MADISON METROPOLITAN SEWERAGE DISTRICT

Subject: Water Utility Board Public Hearing on April 27, 2011

Pressure Zone 4 Water Supply Augmentation

Mapsheet:69

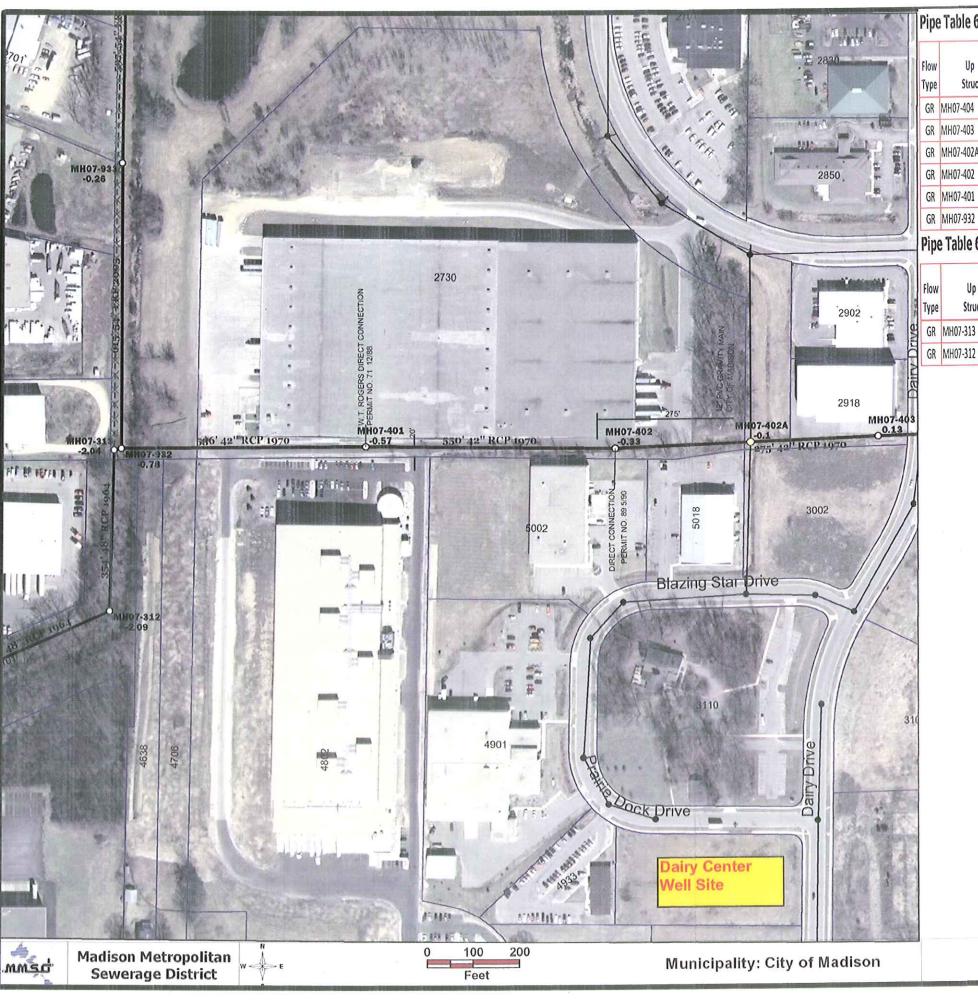
1) <u>Dairy Center site.</u> Potential well sites are identified in the 4900 block of Femrite Drive near its intersection with Dairy Drive. MMSD's nearest facility is the Far East Interceptor, located approximately 1,000 feet to the north of the proposed sites. This 42" concrete sewer was constructed in 1970. MMSD's Northeast Interceptor is located approximately 2,000 feet to the west of these sites. We do not believe a new well at this location would impact the District's existing or future facilities in the area.

Mapsheet:105

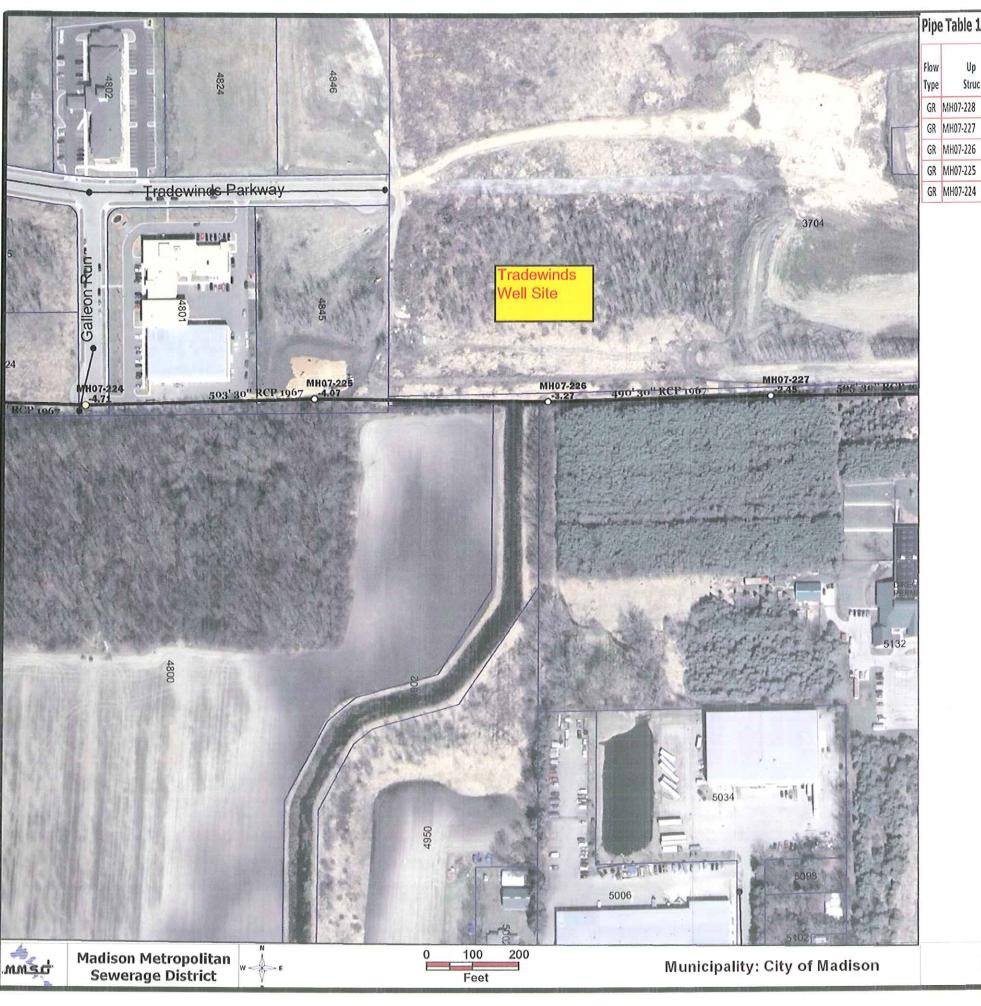
2) Tradewinds site. A potential well site has been proposed at the easterly terminus of Tradewinds Parkway, just south of USH 12/18. MMSD's Southeast Interceptor (Blooming Grove Extension) runs along the southerly property line of this site in an east to west direction. This 30" concrete sewer was constructed in 1967. Installation of a new well at this site may be constrained by the minimum separation requirements from sanitary sewers per NR 811 of the Wisconsin Administrative Code. MMSD does not have any plans to relocate or replace this facility. If this site is selected as the preferred alternative for a new well we would request involvement in the preliminary planning and design of the new facility to address any code-related issues.
